LAKE NONA URBAN LITE APARTMENTS

Specific Parcel Master Plan (SPMP) approval for a multi-family development comprised of 279 dwelling units and 503 parking spaces.

Updated: January 23, 2014

CONCEPTUAL ELEVATIONS

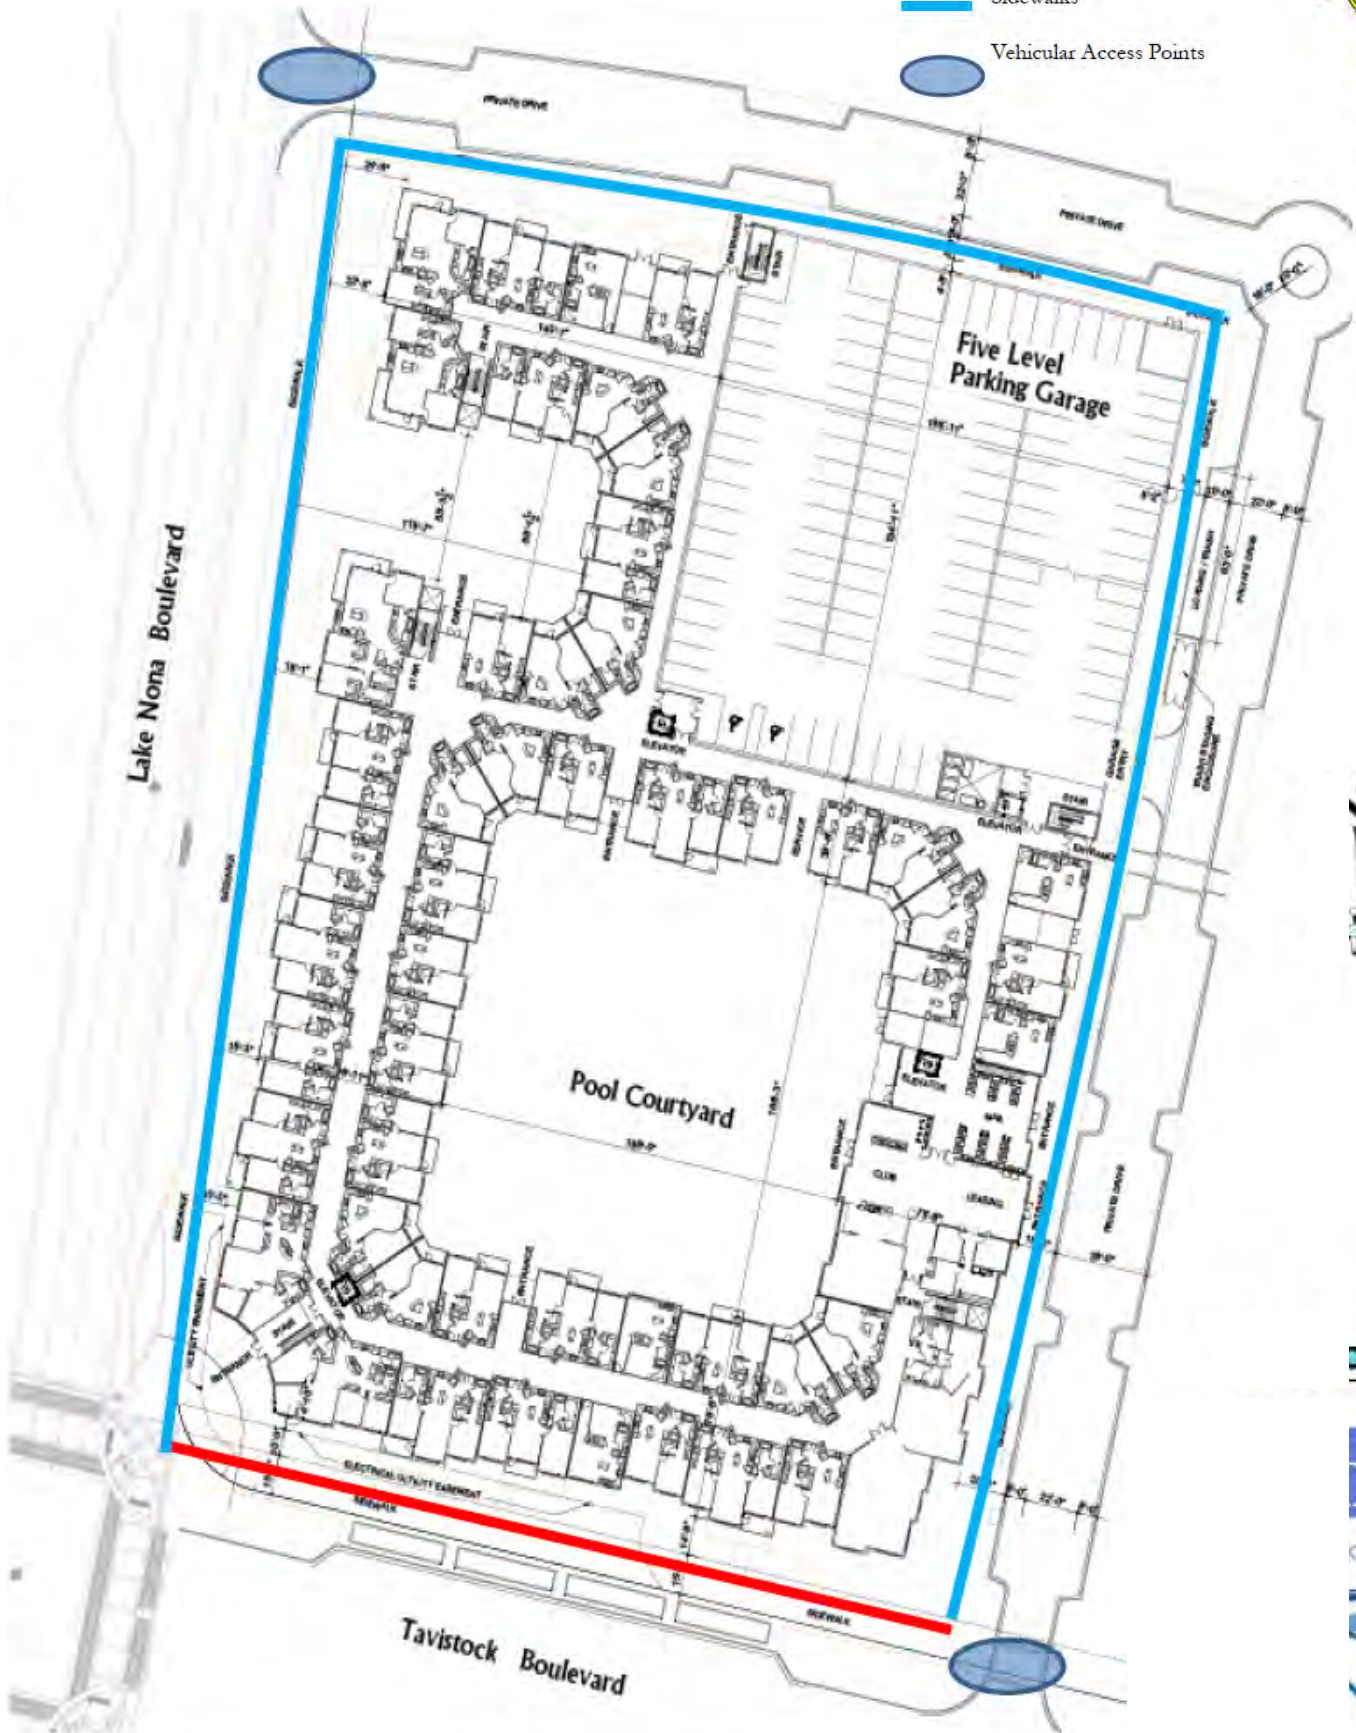
- a. Transparency: A minimum of 15% transparency shall be provided on each floor below the roof line, on all facades. Tinted or reflective glass shall be prohibited.

- b. Finish Floor and entrances: Each façade shall incorporate an entrance from the public ROW to the building. Each entrance shall be articulated at a pedestrian scale to give prominence to the entrance in the overall façade design.

- c. Parking garage:
 - The parking garage shall be finished to match the material or color of the adjacent principal building. The top parapet and corner elements that are adjacent to the principal building shall blend in to complement the overall elevation of the complex.
